Service Letter No. 136A

September 2, 1952

TO: Owners of PA-20 and PA-22 Airplanes with serial numbers  
20-1 through 20-923 and 22-1 through 22-775

SUBJECT: Chafing of Fuel Line and Fuel Valve Operation

Sketch for Service Letter No. 136A

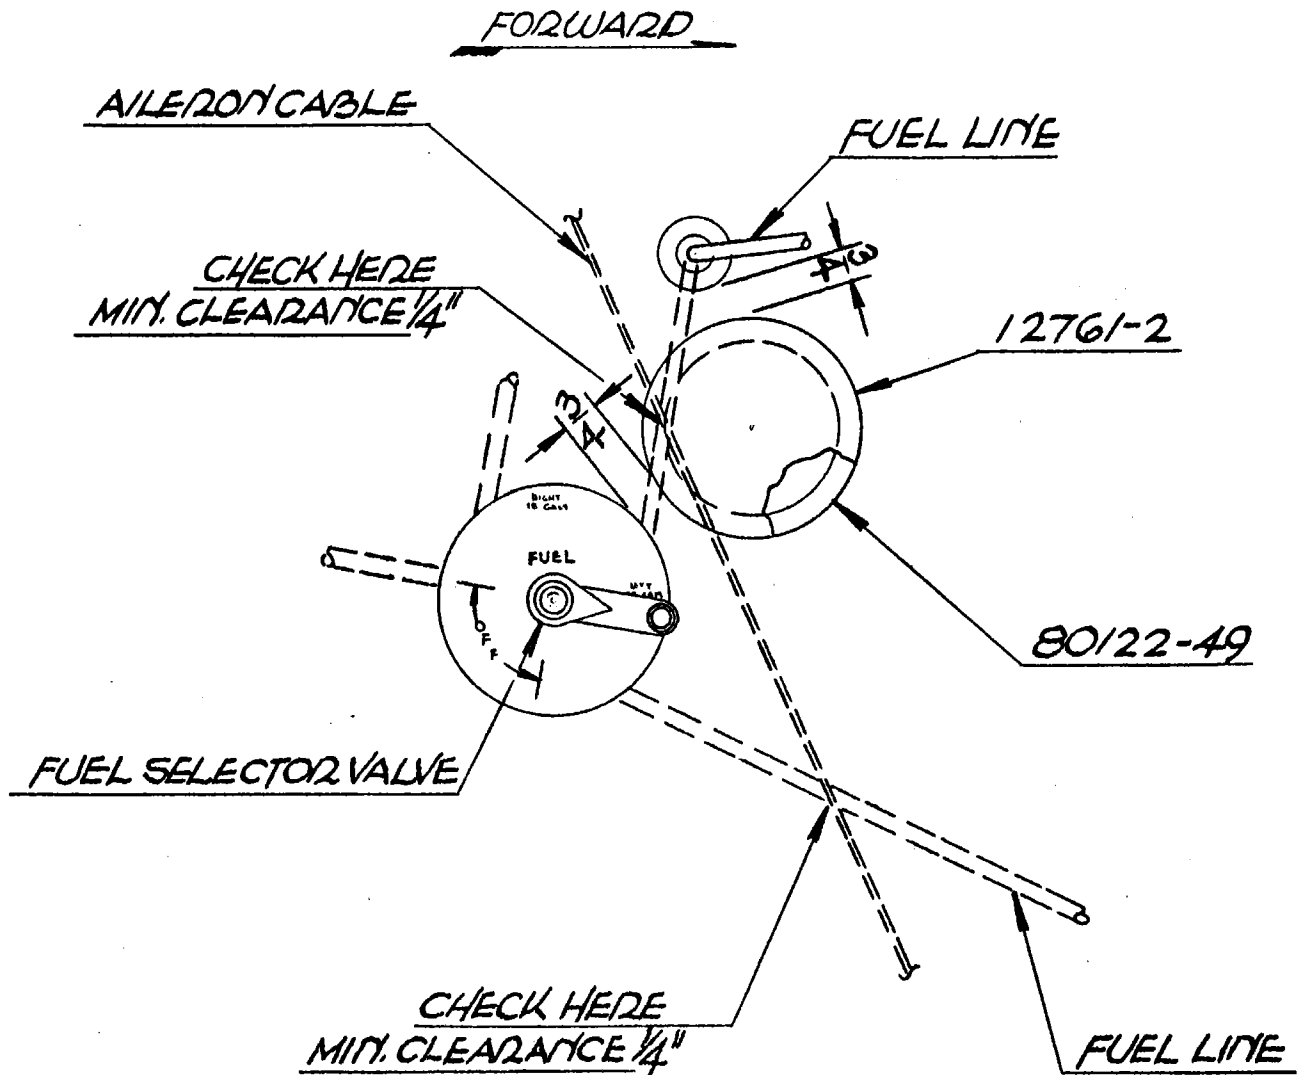
It is necessary that an inspection be made of the aluminum fuel lines forward of the fuel valve.

To accomplish this, dope the pyralin grommet, 80122-49, to the fabric inside the cabin as shown in the sketch. Cut away the fabric enclosed within the grommet.

Inspect the fuel lines for evidence of chafing by the aileron control cable. Check the clearance between the fuel lines and the cable. If 1/4" or more clearance exists no further action is required. If 1/4" minimum clearance has not been provided, form the fuel lines by hand to obtain this minimum clearance. Exercise care while forming to avoid crushing or kinking the fuel lines.

Upon completion, install the cover, 12761-02, as shown in the sketch.
